Subject: Annual Inspection Report
Vaiden Field Airport (A08)

ANNUAL INSPECTION REPORT

**VAIDEN FIELD AIRPORT
MARION, ALABAMA**

Fueling Area Requirements

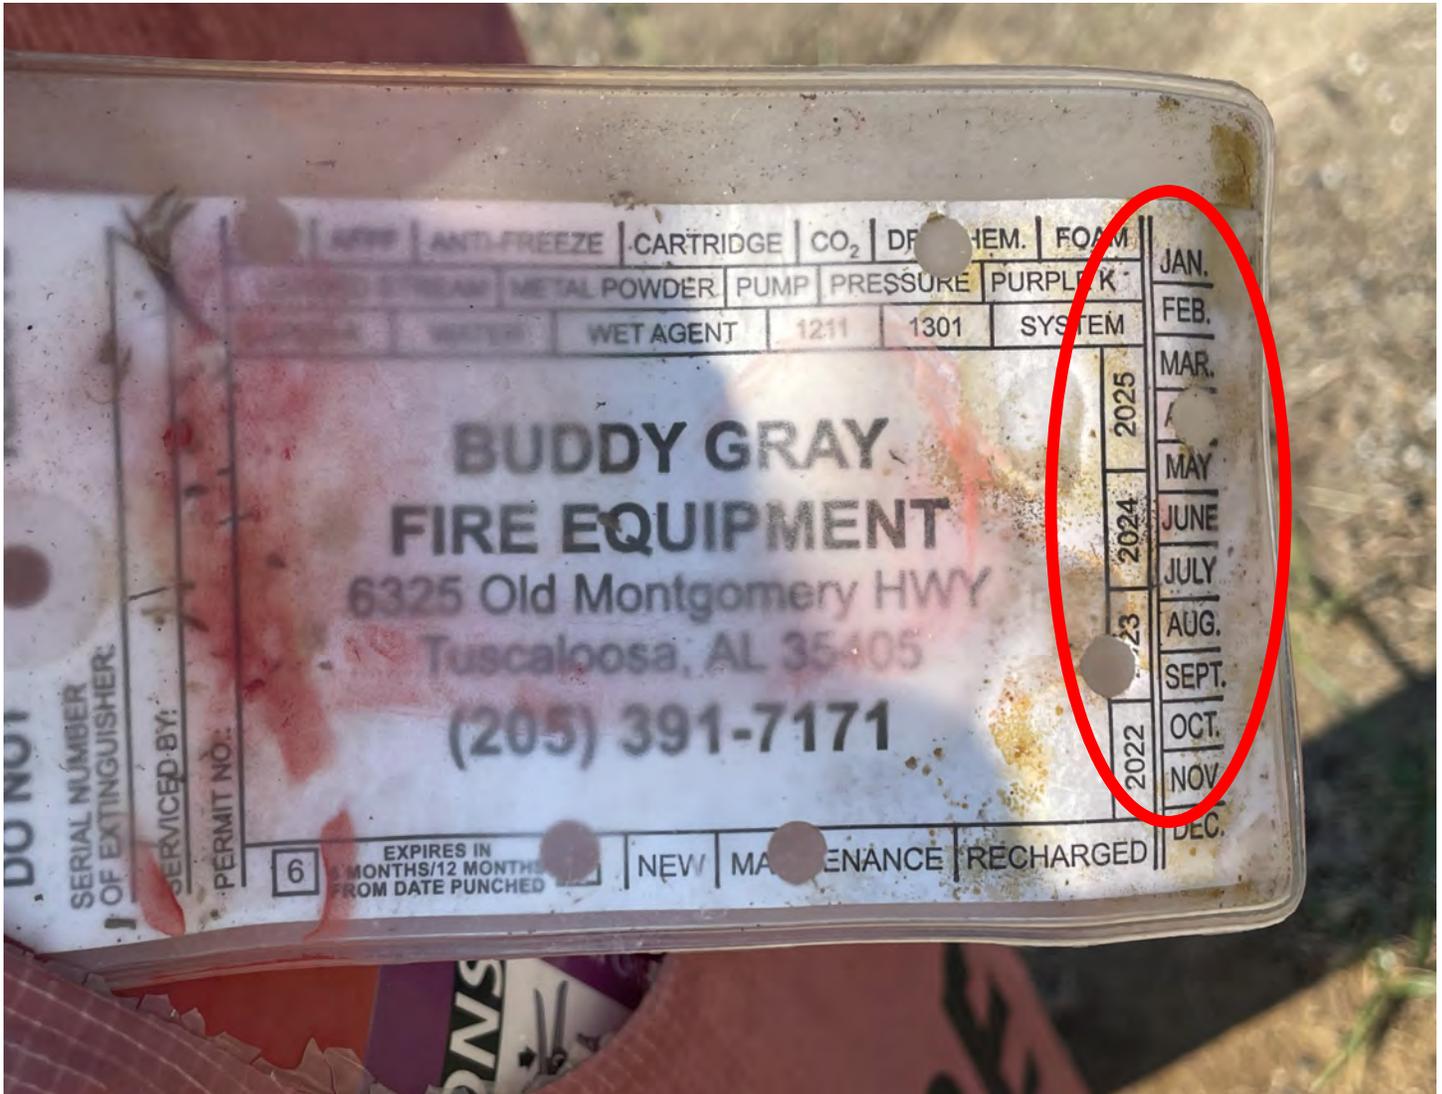
VIOLATION: The fueling area **DOES NOT MEET** state licensing requirements. There were several deficiencies noted during inspection regarding the fueling infrastructure. These items are detailed on the following pages, please refer to them for more information.

Prohibited Activities

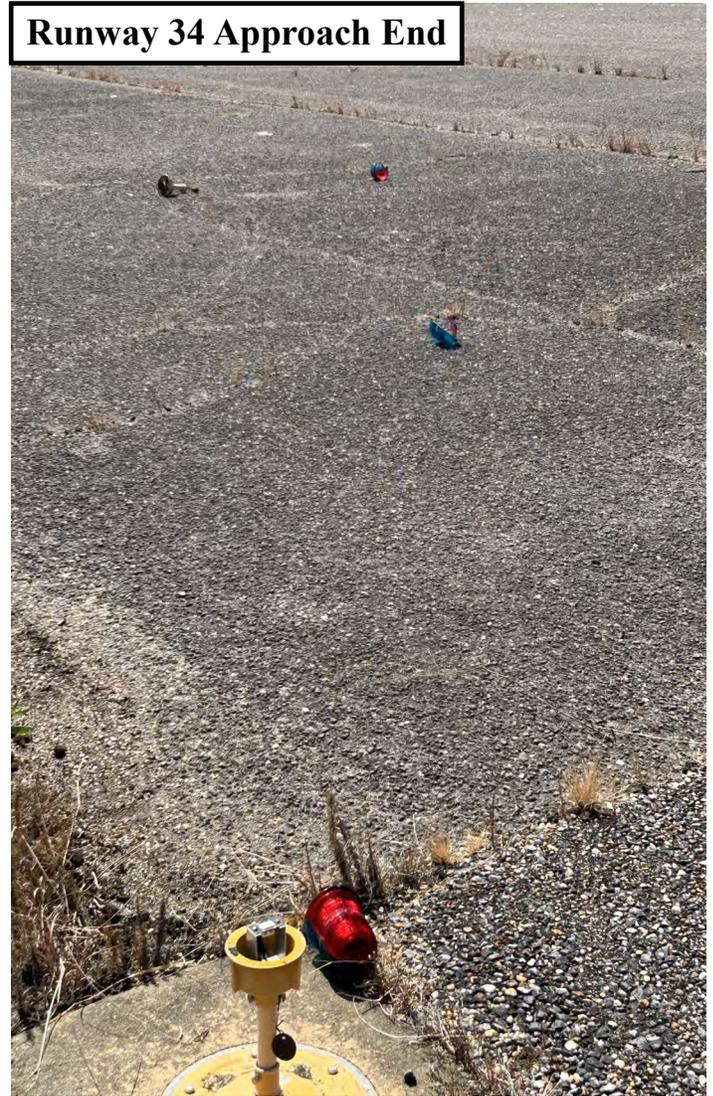
VIOLATION: Several wood burn piles were observed at the northern end of the parallel taxiway. These fires have damaged the pavement and several nails were found in the remains of the fires. Some of these nails have become embedded in the pavement and present a serious damage risk to aircraft. The fires were in close proximity to a dry field adjacent to the taxiway. Please install barriers to entry or enact greater security measures to prevent unauthorized persons from accessing the airfield in the future.
